SUBJECT: COOPER NUCLEAR STATION TECHNICAL SPECIFICATIONS,
PRESSURE-TEMPERATURE LIMITATIONS, CORRECTION TO
AMENDMENT NO. 120 (TAC NO. 65793)

SUBJECT: COOPER NUCLEAR STATION TECHNICAL SPECIFICATIONS,
PRESSURE-TEMPERATURE LIMITATIONS, CORRECTION TO
AMENDMENT NO. 120 (TAC NO. 65793)

Subject: CORRECTION TO CORE CRITICAL PRESSURE-TEMPERATURE CURVE

Figure 3.6.1.b Minimum Temperature for Core Operation (Criticality) - Includes 40°F Margin Required by 10CFR50 Appendix G

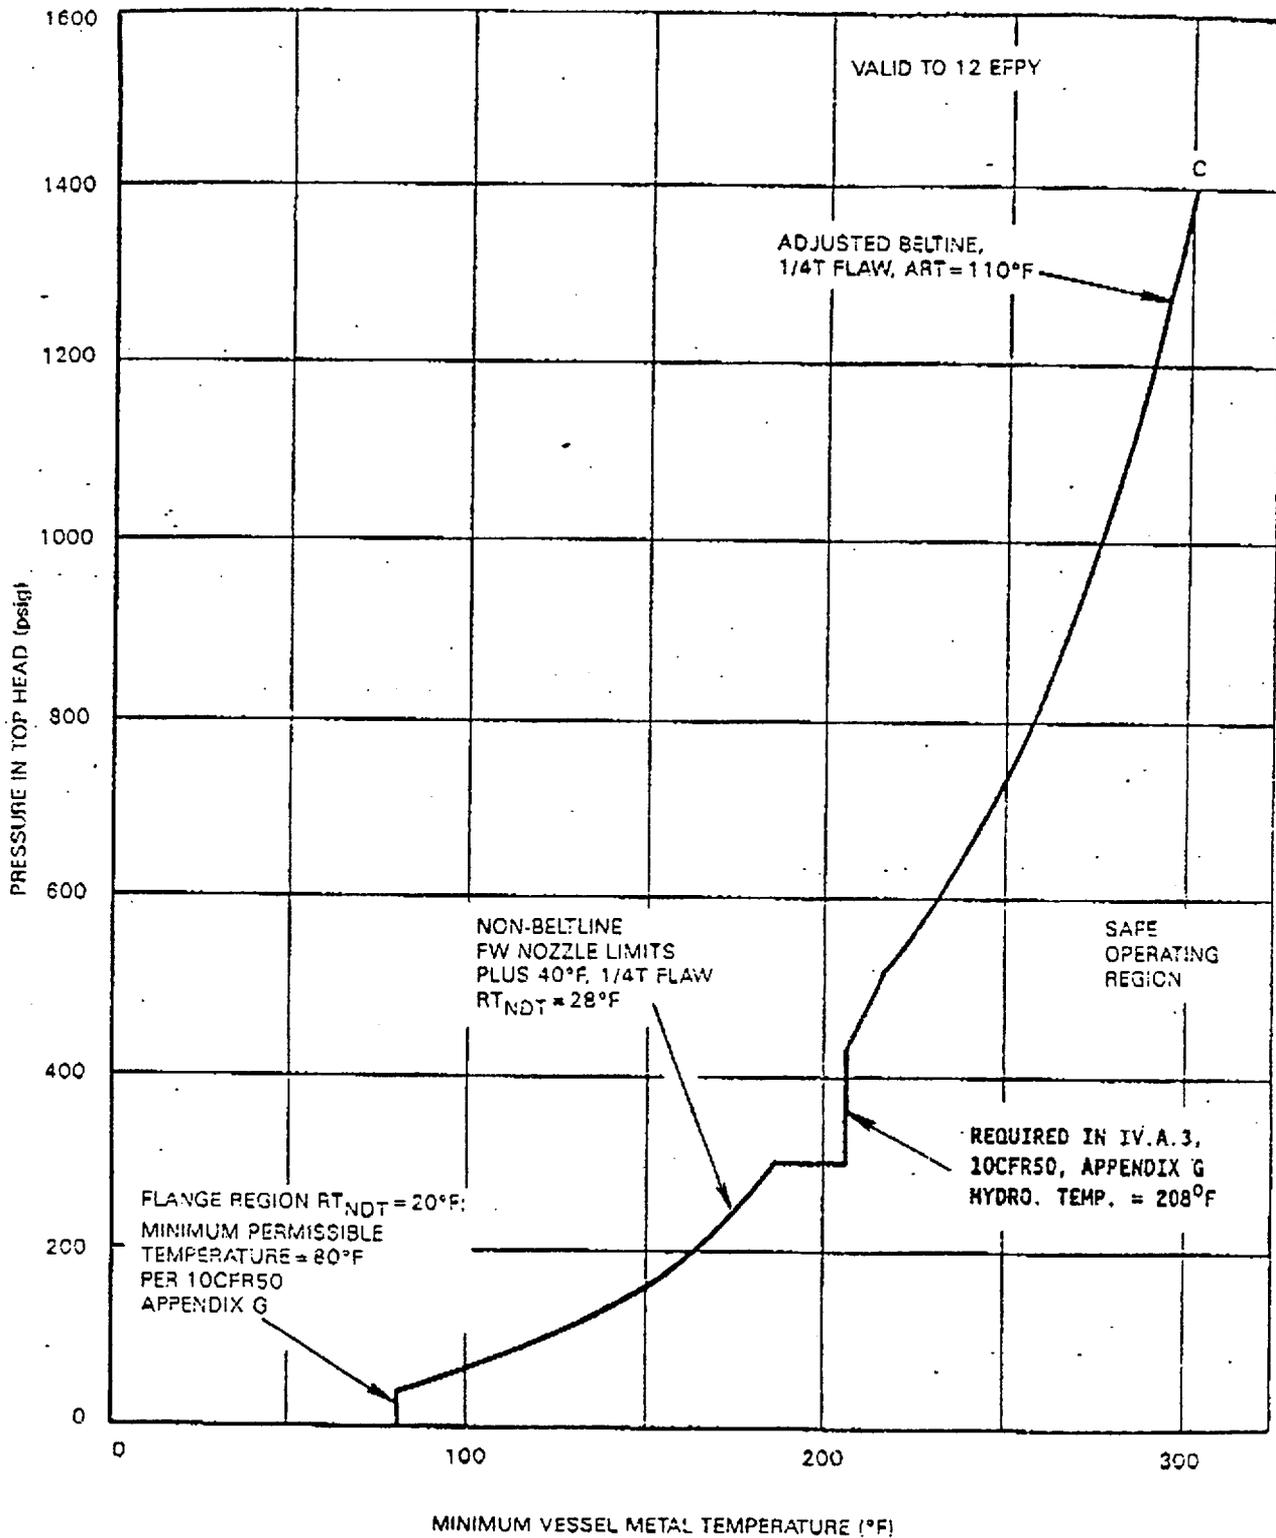
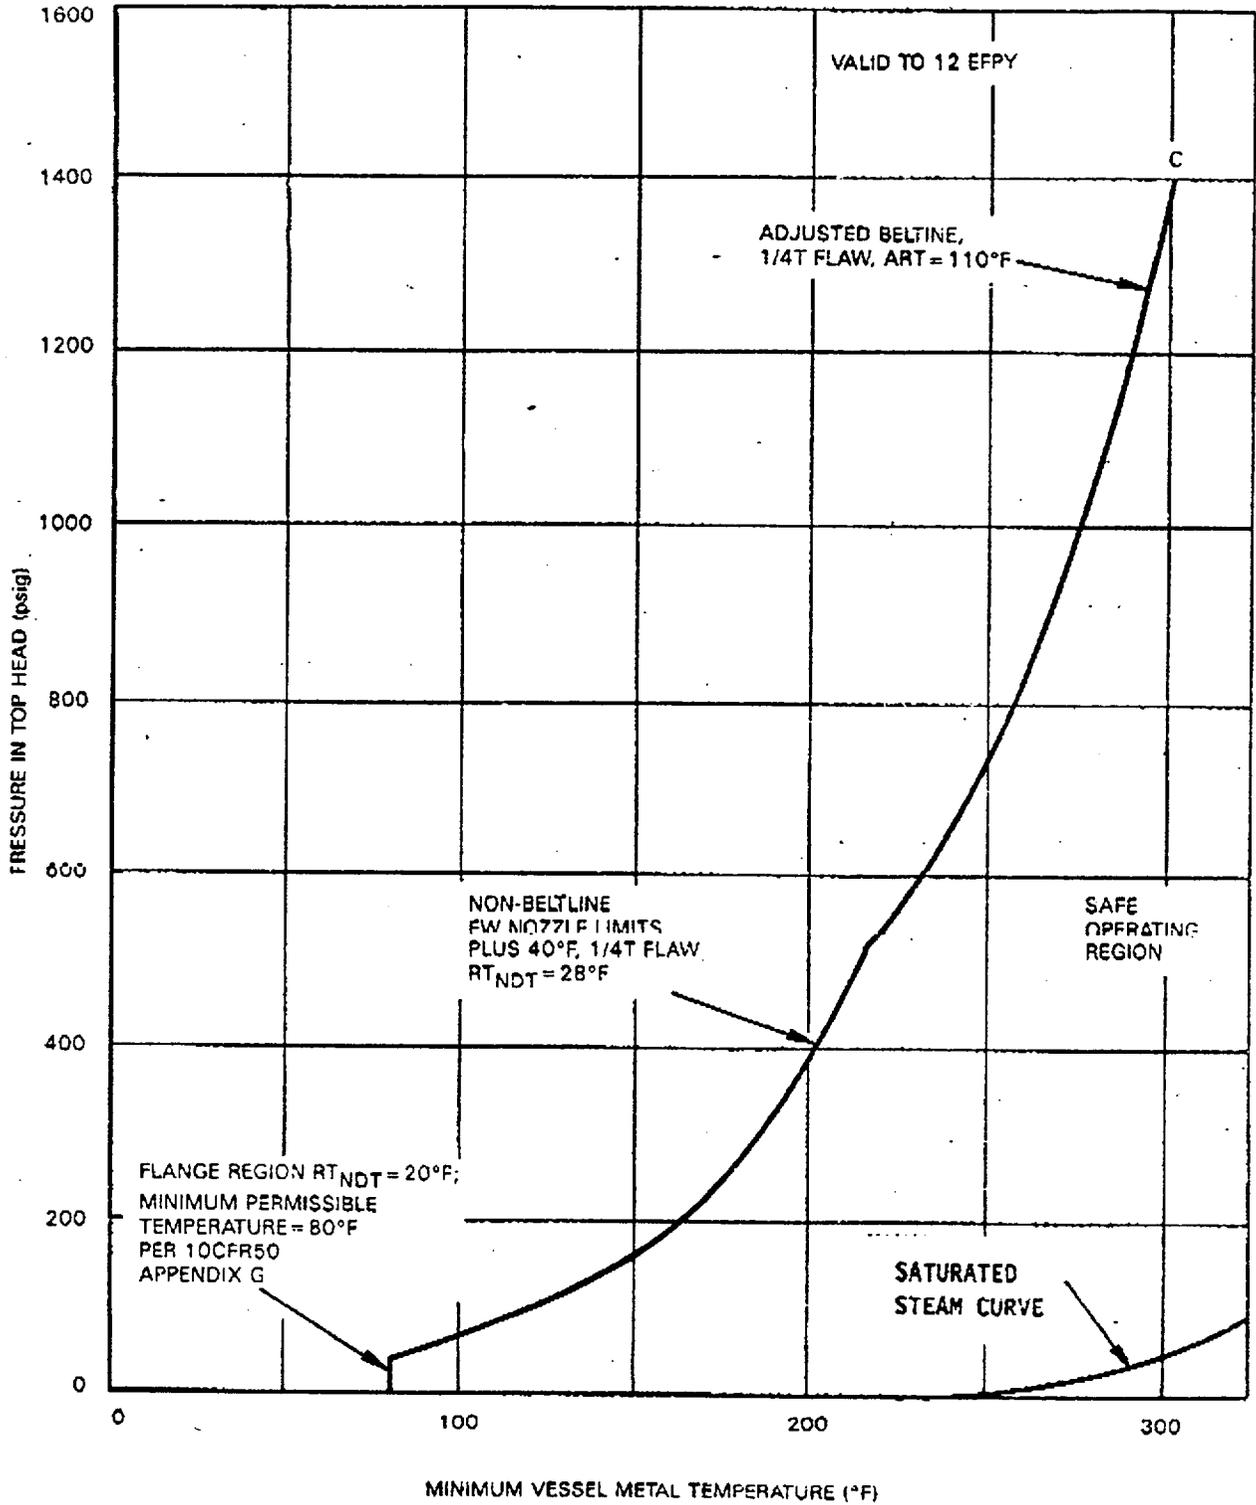
I have reviewed the requirements of 10CFR50, Appendix G and the pressure-temperature limits calculated for the Cooper vessel, and I agree with your conclusion that a correction is needed on the curve for core-critical operation (Curve C). Appendix G allows the BWR to operate with the core critical at temperatures below the hydrostatic pressure test temperature, determined from Curve A, only if maintaining normal water level and with vessel pressure below 312 psig (20% of preservice hydrotest pressure). This second condition is relevant to the Cooper core-critical curve because the Curve A hydrostatic test temperature is unusually high. The corrected Curve C is attached as Figure 1.

In most BWR analyses, the pressure-temperature limits for the feedwater nozzle are more limiting than the hydrotest temperature requirement, because most required pressure test temperatures are below 200°F. However, the Cooper curves include a large irradiation shift based on the surveillance test results, resulting in a pressure test temperature of 208°F at 1100 psig. This causes the step seen in Figure 1, the corrected Curve C, in order to meet the requirement of paragraph IV.A.3 of Appendix G.

The region of pressure and temperature affected by the change is a region in which the BWR cannot operate with the core critical. The reactor water level must be in the normal operating range, or else the reactor will SCRAM. With normal water level, the only way to pressurize the large "bubble" of vapor in the steam dome is to increase pressure according to the P-T relationship for saturated steam. As shown in Figure 2 attached, the saturated steam relationship is far to the right in the safe operating region. Therefore, the omission of the step in Curve C does not impact safety.

A corrected Figure 3.6.1.b dated June 23, 1988 is also enclosed. The Federal Register notices and Safety Evaluation associated with Amendment 120 are consistent with the enclosed revised figure. This figure replaces that provided in Amendment 120.

Figure 3.6.1.b Minimum Temperature for Core Operation (Criticality) - Includes 40°F Margin Required by 10CFR50 Appendix G

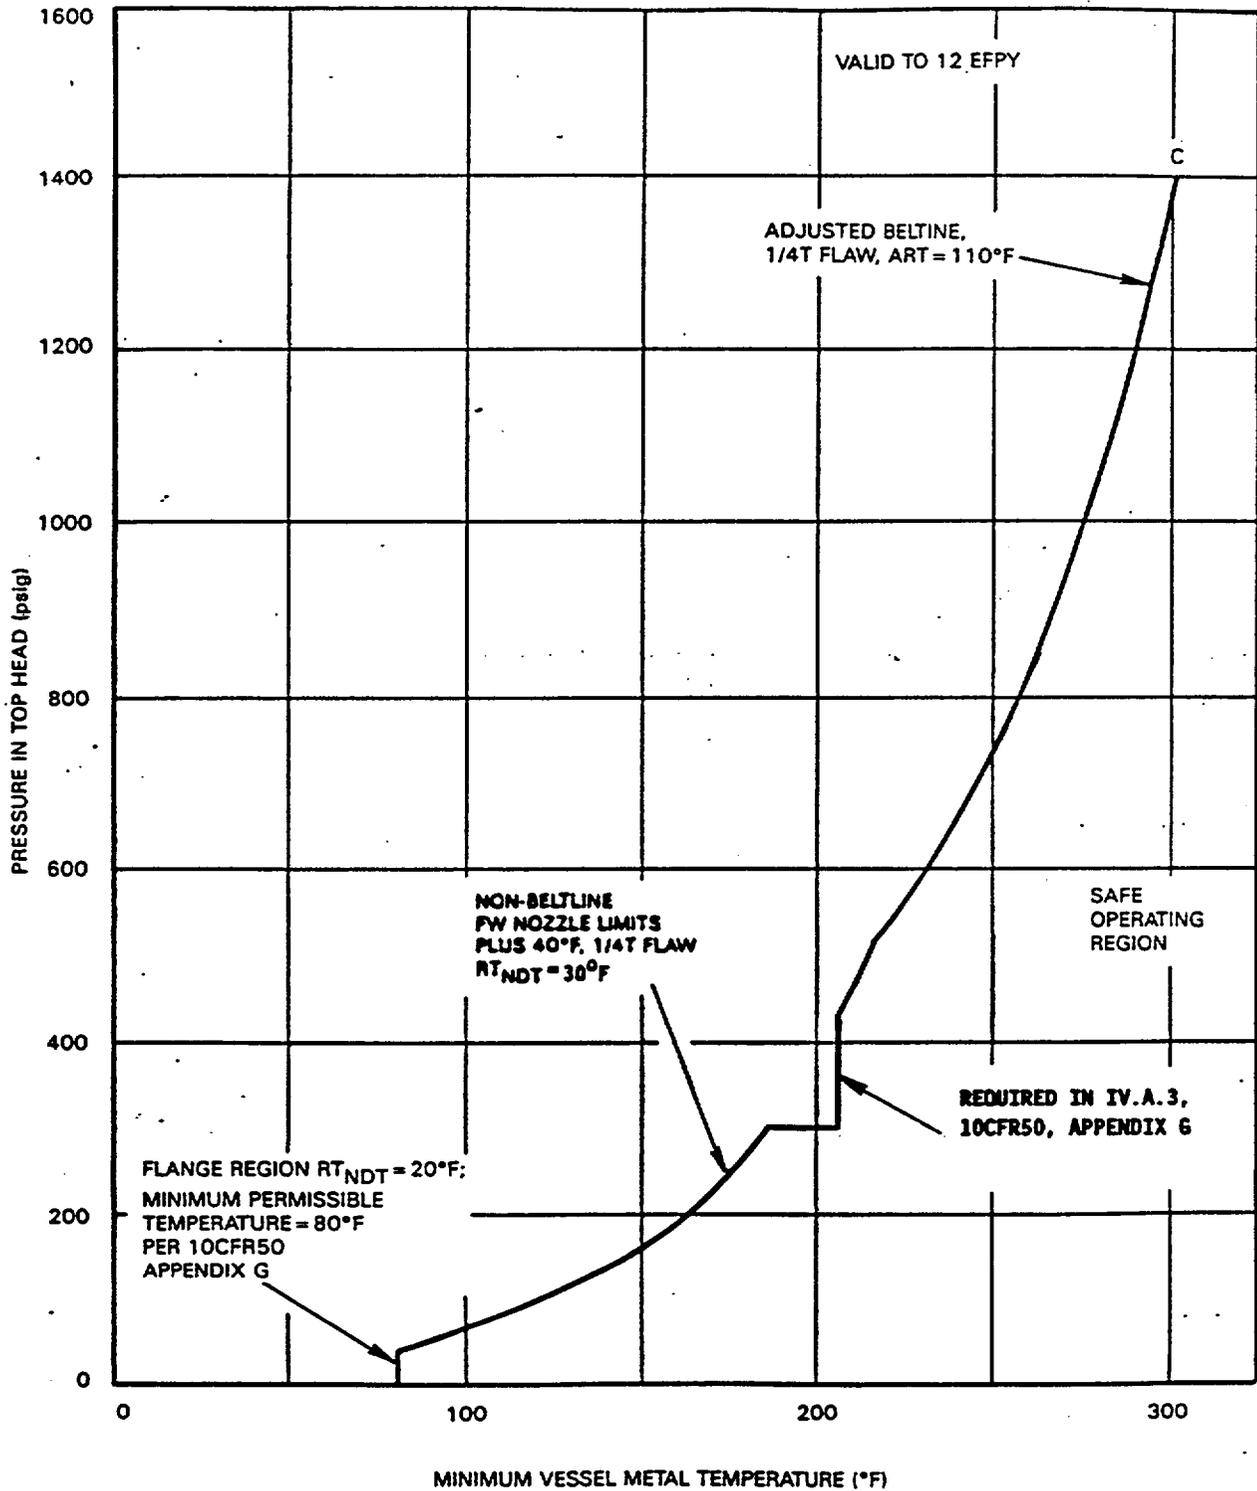
A corrected Figure 3.6.1.b dated June 23, 1988 is also enclosed. The Federal Register notices and Safety Evaluation associated with Amendment 120 are consistent with the enclosed revised figure. This figure replaces that provided in Amendment 120.
